**MOORE PUBLIC SCHOOLS -
CENTRAL JUNIOR HIGH SCHOOL –
STEM CLASSROOM ADDITION**

CONSTRUCTION BULLETIN NO. 7

February 9, 2026

3 SECTION
S701 SCALE: 3/4"=1'-0"

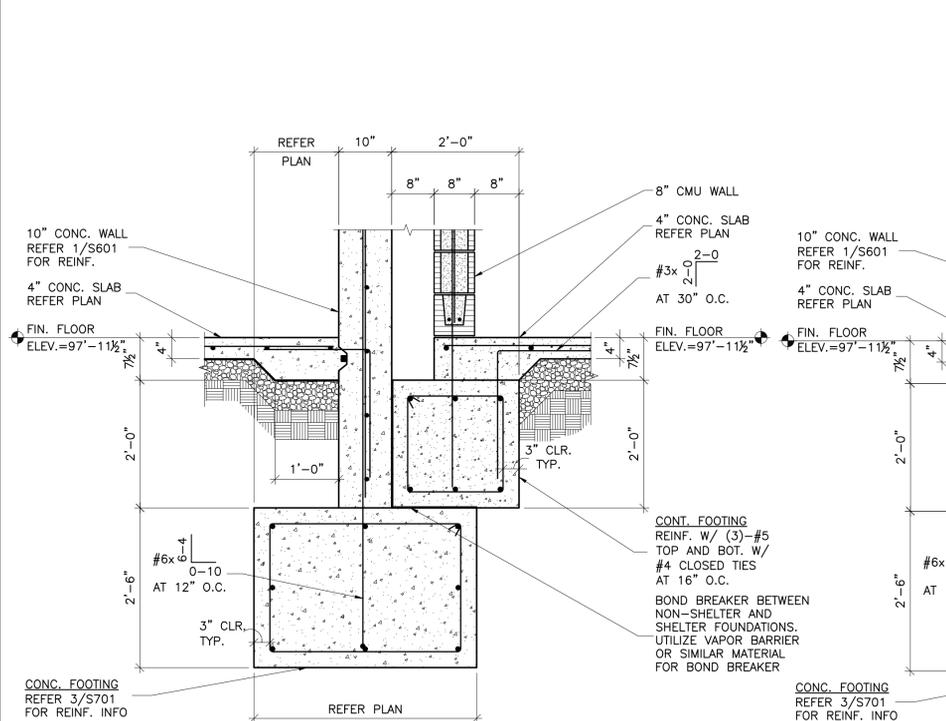
1. SHEET S701 – ADDED FOOTING DETAILS 3AS701 & 3BS701. REVISED DETAILS 3S701 & 4S701.
2. SHEET A106 – REVISED ENLARGED FLOOR PLAN 1A106 AS INDICATED.
3. SHEET A107 – REVISED REFLECTED CEILING PLAN 1A107 AS INDICATED.

1 REFLECTED CEILING PLAN - AREA "A"
1/8" = 1'-0"
NORTH

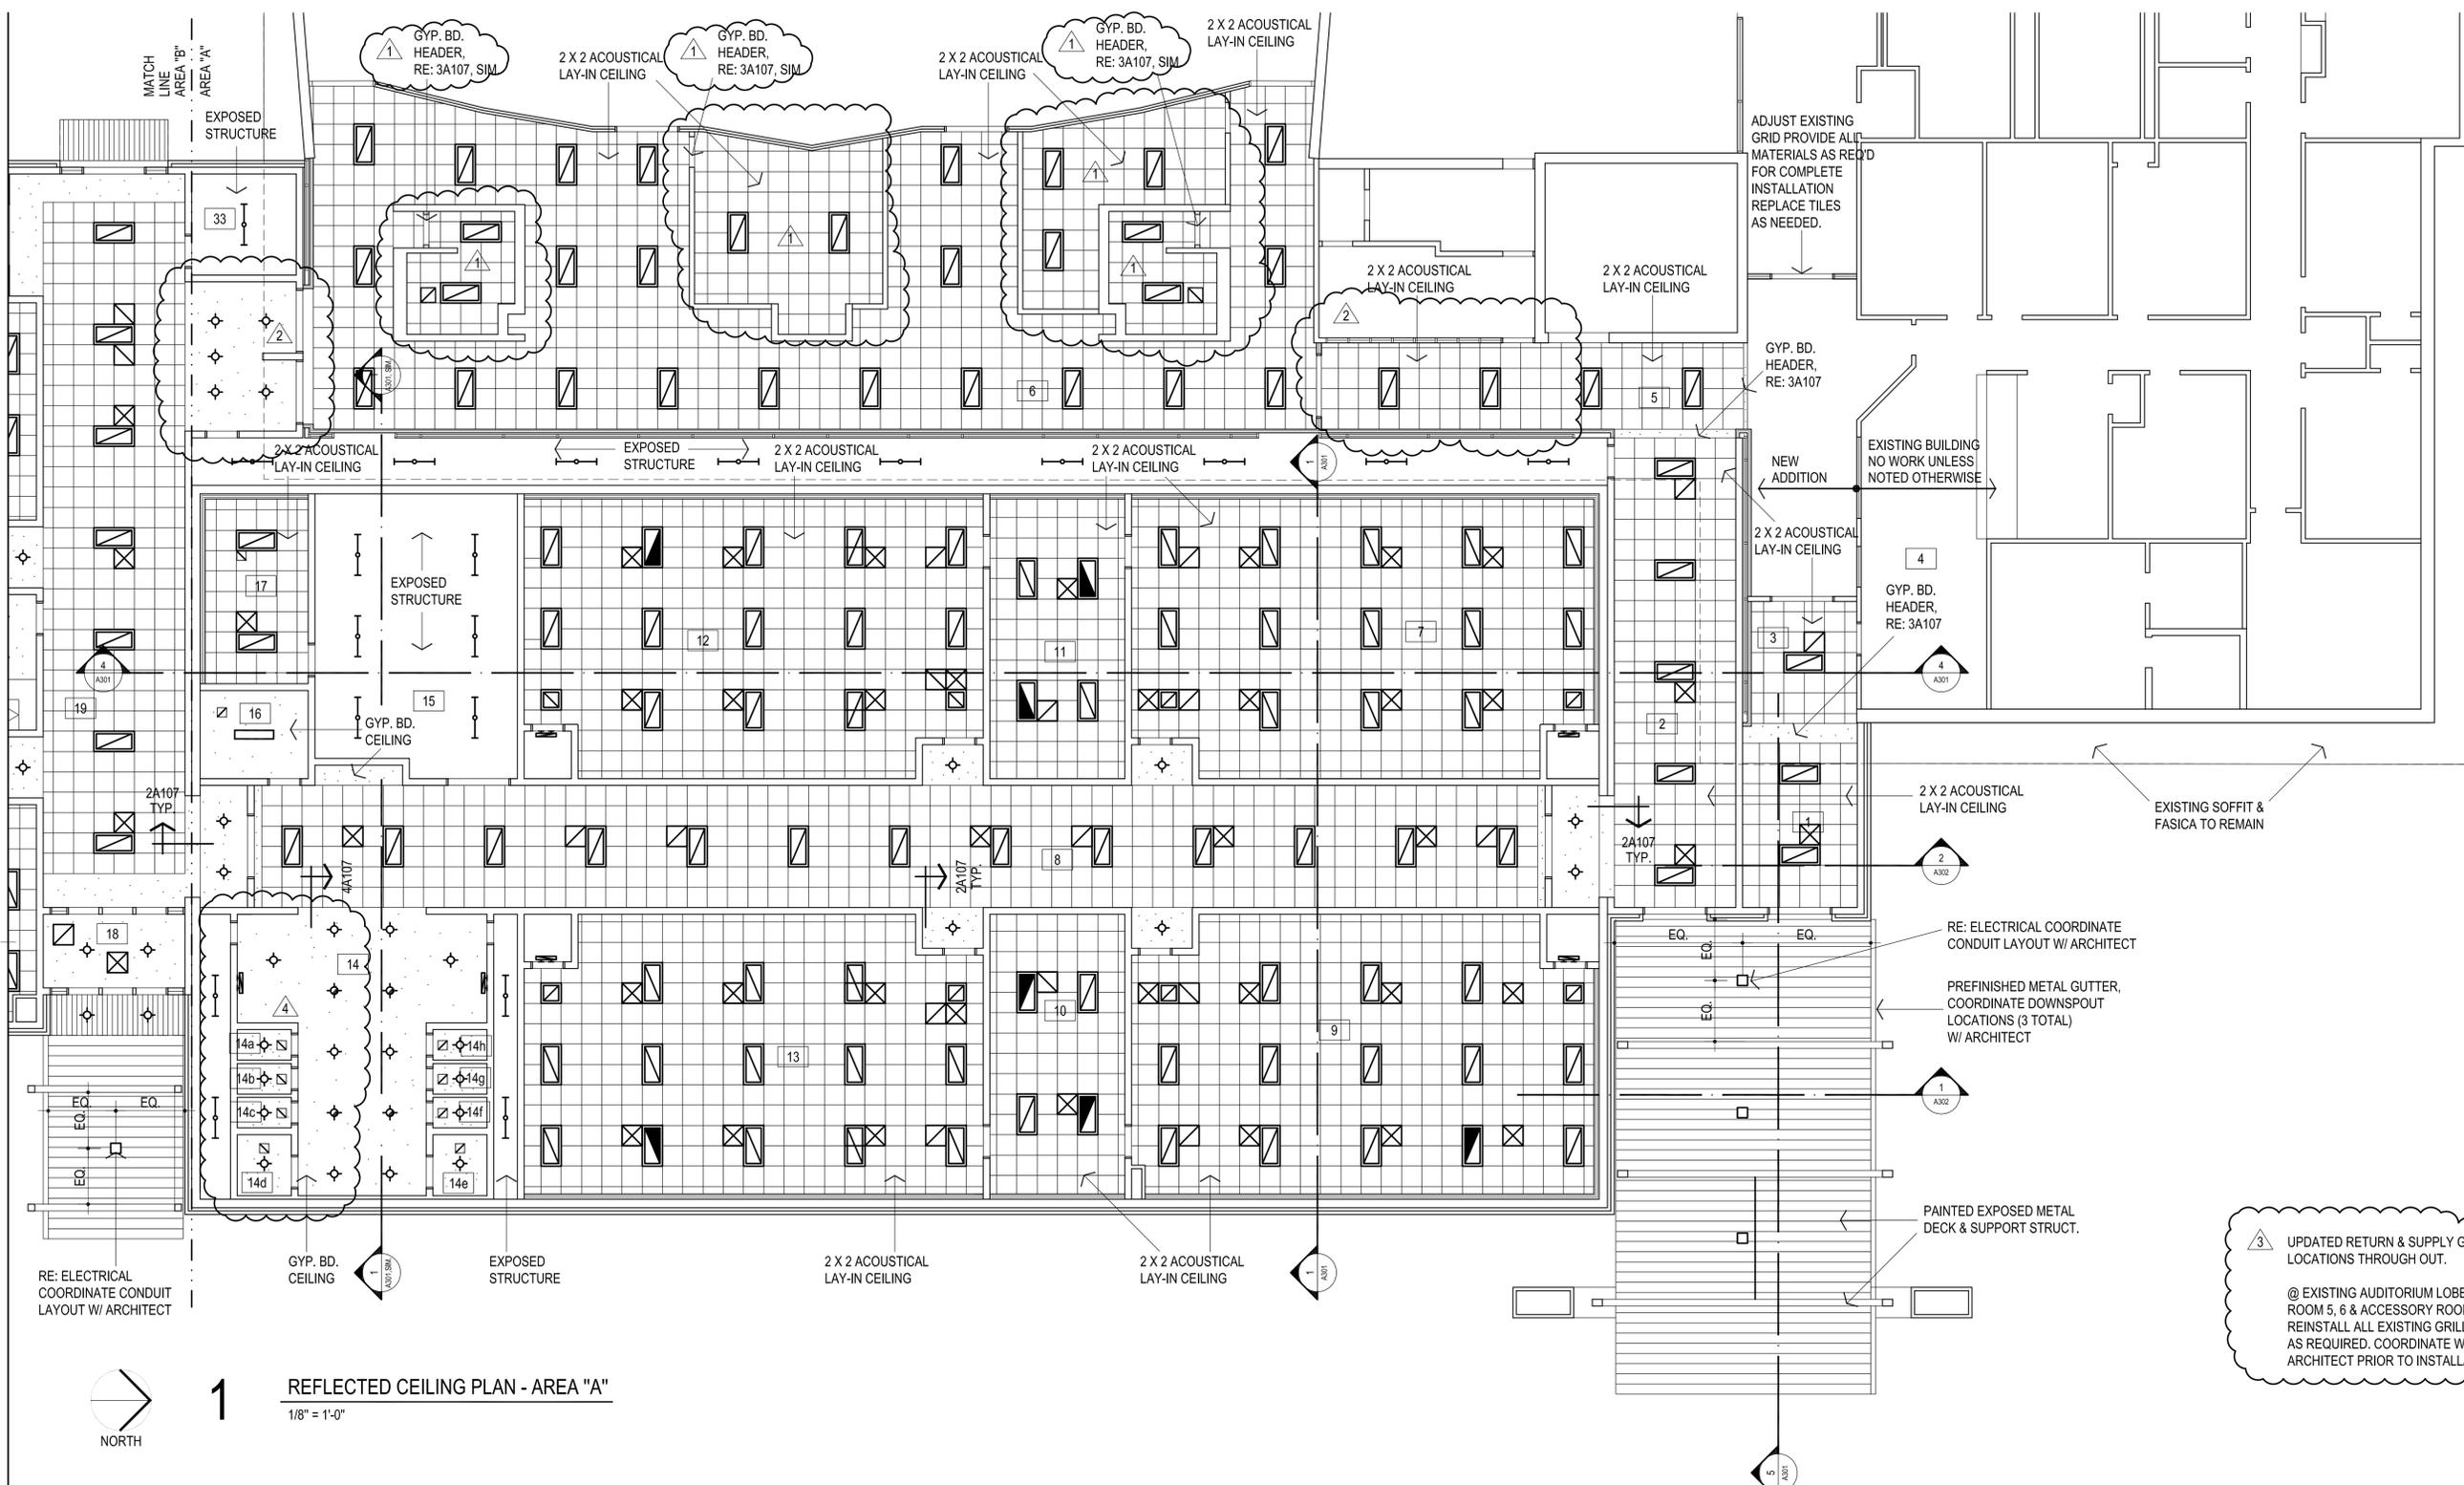
3 UPDATED RETURN & SUPPLY GRILL LOCATIONS THROUGH OUT.
@ EXISTING AUDITORIUM LOBBY - ROOM 5, 6 & ACCESSORY ROOMS, REINSTALL ALL EXISTING GRILLS AS REQUIRED. COORDINATE W/ ARCHITECT PRIOR TO INSTALLATION.
